TOWN OF LEESBURG
NOTICE OF TOWN COUNCIL PUBLIC HEARING
TO CONSIDER REZONING APPLICATION TLZM-2015-0009
VILLAGE AT LEESBURG
A CONCEPT PLAN AND PROFFER AMENDMENT

Subject: TLZM-2015-0009, Village at Leesburg Child Care Center

Proposal: A request to amend TLZM 2014-0006 Village at Leesburg to allow a child care center use in a portion of Building M of Land Bay B as shown on the Land Use Map and Legend on Sheet 3A.

Figure 4. Proposed Land Use Map

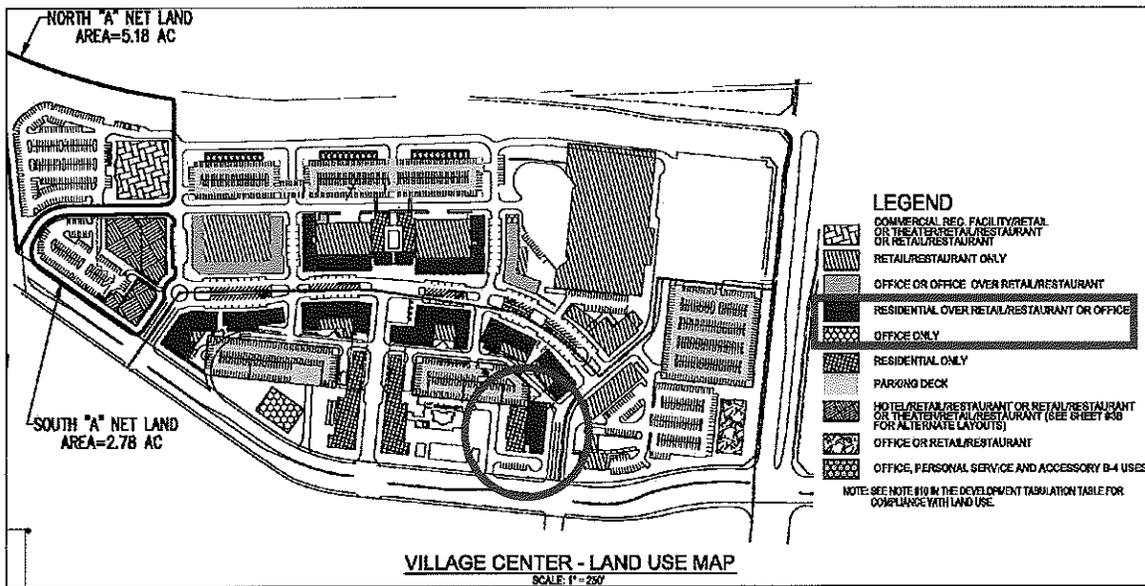
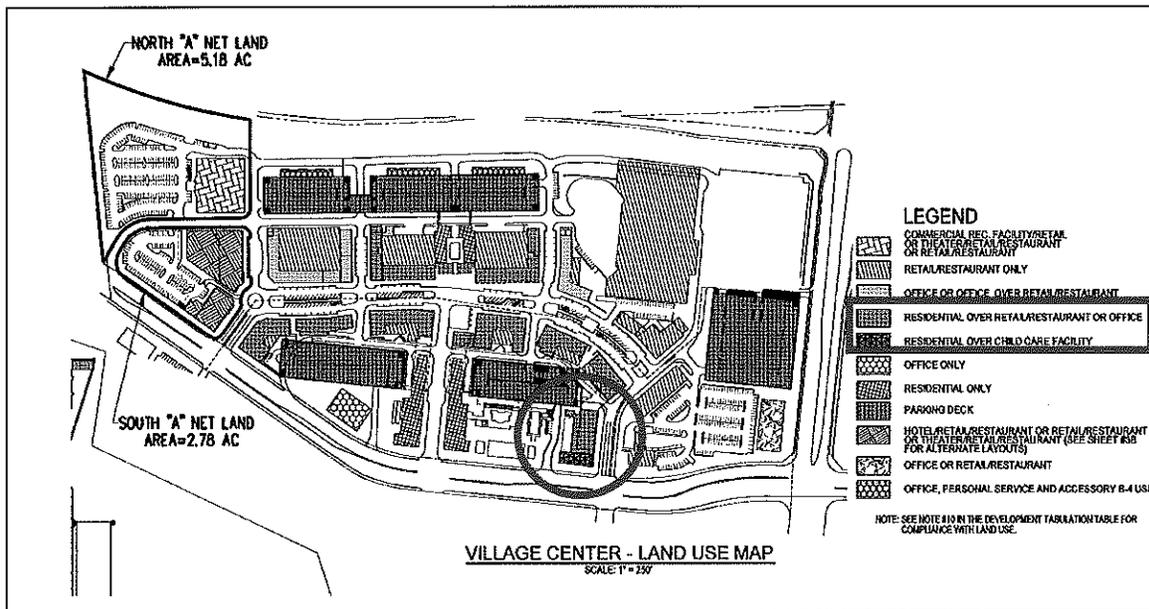
Land Use Map Changes. Figure 3 below depicts the *existing approved* use locations in Land Bays A and B. Figure 4 depicts the *proposed* use locations. Currently, “Residential over Restaurant/Retail or Office” is permitted in the southeastern portion of Building M while “Residential Only” is permitted in the northwestern portion of Building M. This amendment would revise Building M to allow for “Residential over Child Care Facility” in the portion of Building M closest to Russell Branch Parkway (Suite 100) while the remainder of Building M would allow for “Residential over Retail/Restaurant or Office” as shown in Figure 4.

In addition to these revisions to the concept plan, language in the proffers must be revised for consistency with the Land Use Map and Legend revisions on the concept plan.

Figure 8. Building M Proposed Daycare and Recreation Area Layout

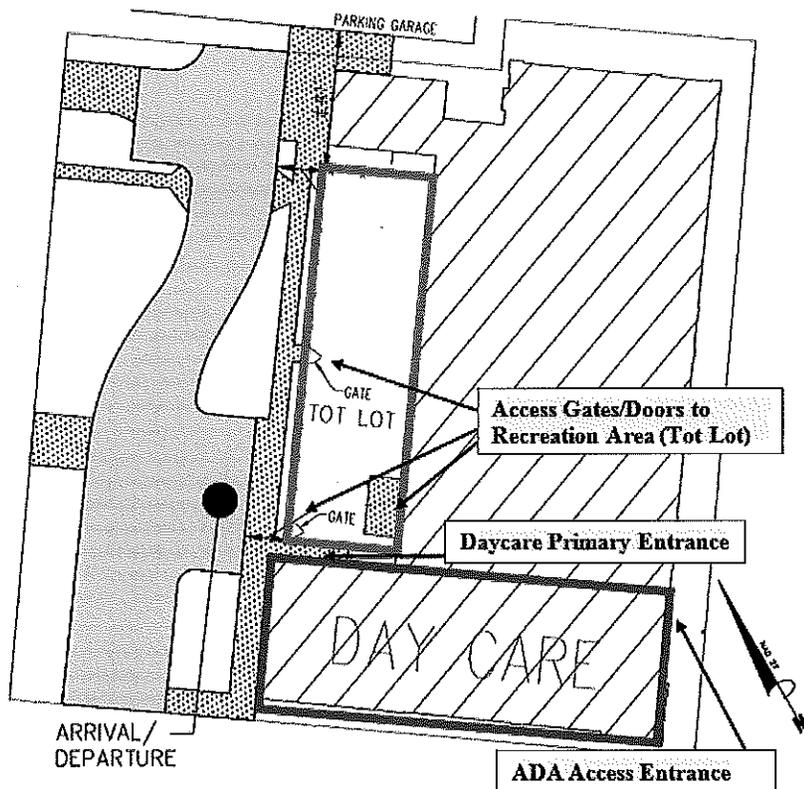
VII. Use Standard Criteria for a Child Care Center: Zoning Ordinance Section 9.3.4 provides seven specific use standards for child care centers as discussed below. The layout of the recreation area is shown in Figure 8 below.

Uncontrolled access door. An existing emergency access door is currently located along the northwest side of Building M *within* the fenced recreation area, thereby giving direct access to the play area from inside Building M. However, the hallway leading to this door is not included as part of the lease area for the child care center. The applicant must explain in the proffers or on the concept plan if this door is to provide access to the recreation area and, if so, who has access to use that door.

DAYCARE USE - ADA ACCESSIBILITY
SCALE: 1"=50'

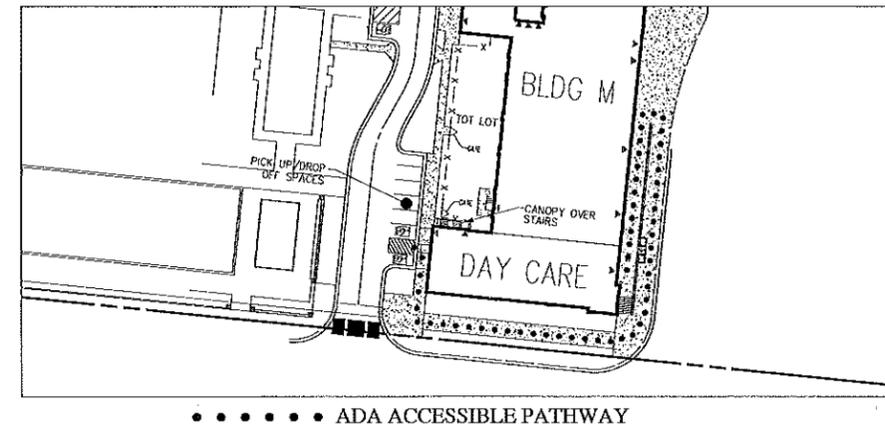
ADA accessibility. The ADA accessibility detail on Sheet 4 of the Rezoning Concept Plan needs to be revised to show the correct ADA accessible pathway from the garage parking to the ADA accessible entrance along Village Market Boulevard. The applicant has agreed to provide this revised detail, but the applicant must revise the concept plan to ensure that this commitment is met.

- 3. Eliminate the possibility of the uncontrolled access door.
 - 4. Incorporate the parking plan, including a pamphlet and a parking director.
 - 5. Correct the ADA Accessibility Map on Sheet 4.
